**Source:** SA5 (Telecom Management)  
**Title:** 3 Rel-4/5/6 CR 32.403 Radio link additions  
**Document for:** Decision  
**Agenda Item:** 7.5.3

⌘ **32.403 CR 026** ⌘ rev - ⌘ Current version: **4.5.0** ⌘

<b>Title:</b>	⌘ Correction of "Radio link addition" measurements		
<b>Source:</b>	⌘ SA5 ( <a href="mailto:llrui@bupt.edu.cn">llrui@bupt.edu.cn</a> , <a href="mailto:liyewen@chinamobile.com">liyewen@chinamobile.com</a> )		
<b>Work item code:</b>	⌘ OAM-PM	<b>Date:</b>	⌘ 27/02/2004
<b>Category:</b>	⌘ <b>F</b>	<b>Release:</b>	⌘ Rel-4
	Use <u>one</u> of the following categories: <b>F</b> (correction) <b>A</b> (corresponds to a correction in an earlier release) <b>B</b> (addition of feature), <b>C</b> (functional modification of feature) <b>D</b> (editorial modification) Detailed explanations of the above categories can be found in 3GPP <a href="#">TR 21.900</a> .		Use <u>one</u> of the following releases: 2 (GSM Phase 2) R96 (Release 1996) R97 (Release 1997) R98 (Release 1998) R99 (Release 1999) Rel-4 (Release 4) Rel-5 (Release 5) Rel-6 (Release 6)

**Figure: Relation between Iub interface and Iur interface**

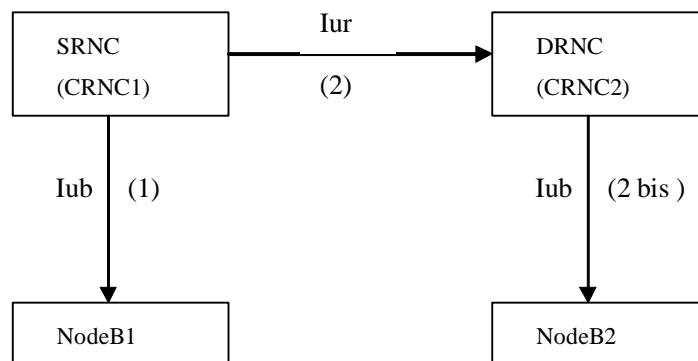
<b>Reason for change:</b>	⌘ Radio links can be added by the "Radio Link Setup" procedure and the "Radio Link Addition" procedure of both NBAP(25.433) and RNSAP(25.423), but "Radio link additions" measurements currently only concerns two of the four procedures. Furthermore, when "RADIO LINK SETUP FAILURE" or "RADIO LINK ADDITION FAILURE" is received, some radio links may be established successfully, and they are not added to "Successful radio link additions" measurement at present. Thirdly, when lur procedure is measured, the conditions of the measurements are inconsistent with the measurement object classes of those.
<b>Summary of change:</b>	⌘ Modify the conditions of "Radio link additions" measurements.
<b>Consequences if not approved:</b>	⌘ The conditions of the measurements will be inconsistent with the descriptions and the measurement object classes of that measurements.

This subclause has separated measurements for both Iur interface and Iub interface. From the above figure and description, we can see that the Iub interface measurements and Iur interface measurements overlap in some degree. Based on maintenance requirements, these two kinds measurements are needed and they are useful for operators to evaluate both the Iub interface and Iur interface, and to analyze all the failure cases they concern.

**Figure: Relation between Iub interface and Iur interface**

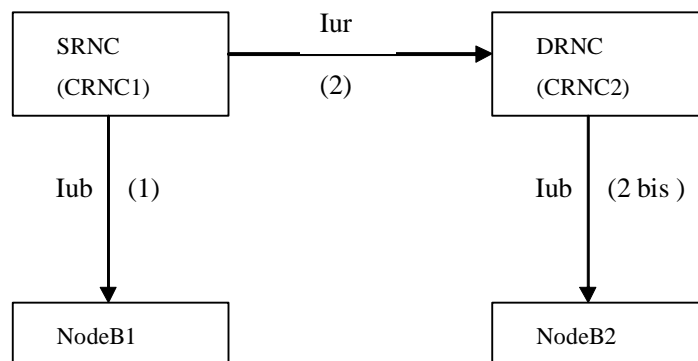
<b>Reason for change:</b>	⌘ Radio links can be added by the "Radio Link Setup" procedure and the "Radio Link Addition" procedure of both NBAP(25.433) and RNSAP(25.423), but "Radio link additions" measurements currently only concerns two of the four procedures. Furthermore, when "RADIO LINK SETUP FAILURE" or "RADIO LINK ADDITION FAILURE" is received, some radio links may be established successfully, and they are not added to "Successful radio link additions" measurement at present. Thirdly, when lur procedure is measured, the conditions of the measurements are inconsistent with the measurement object classes of those.
<b>Summary of change:</b>	⌘ Modify the conditions of "Radio link additions" measurements.
<b>Consequences if not approved:</b>	⌘ The conditions of the measurements will be inconsistent with the descriptions and the measurement object classes of that measurements.

This subclause has separated measurements for both Iur interface and Iub interface. From the above figure and description, we can see that the Iub interface measurements and Iur interface measurements overlap in some degree. Based on maintenance requirements, these two kinds measurements are needed and they are useful for operators to evaluate both the Iub interface and Iur interface, and to analyze all the failure cases they concern.

**Figure: Relation between Iub interface and Iur interface**

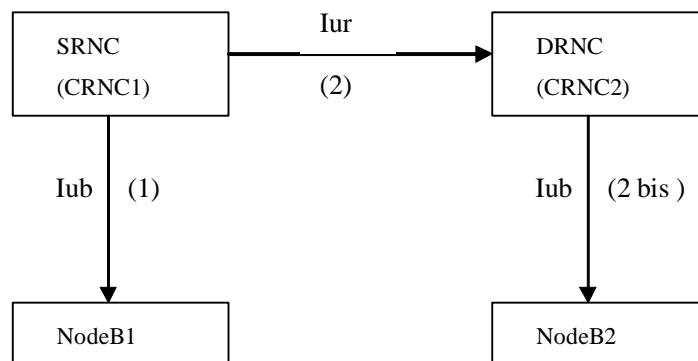
<b>Reason for change:</b>	⌘ Radio links can be added by the "Radio Link Setup" procedure and the "Radio Link Addition" procedure of both NBAP(25.433) and RNSAP(25.423), but "Radio link additions" measurements currently only concerns two of the four procedures. Furthermore, when "RADIO LINK SETUP FAILURE" or "RADIO LINK ADDITION FAILURE" is received, some radio links may be established successfully, and they are not added to "Successful radio link additions" measurement at present. Thirdly, when lur procedure is measured, the conditions of the measurements are inconsistent with the measurement object classes of those.
<b>Summary of change:</b>	⌘ Modify the conditions of "Radio link additions" measurements.
<b>Consequences if not approved:</b>	⌘ The conditions of the measurements will be inconsistent with the descriptions and the measurement object classes of that measurements.

This subclause has separated measurements for both Iur interface and Iub interface. From the above figure and description, we can see that the Iub interface measurements and Iur interface measurements overlap in some degree. Based on maintenance requirements, these two kinds measurements are needed and they are useful for operators to evaluate both the Iub interface and Iur interface, and to analyze all the failure cases they concern.
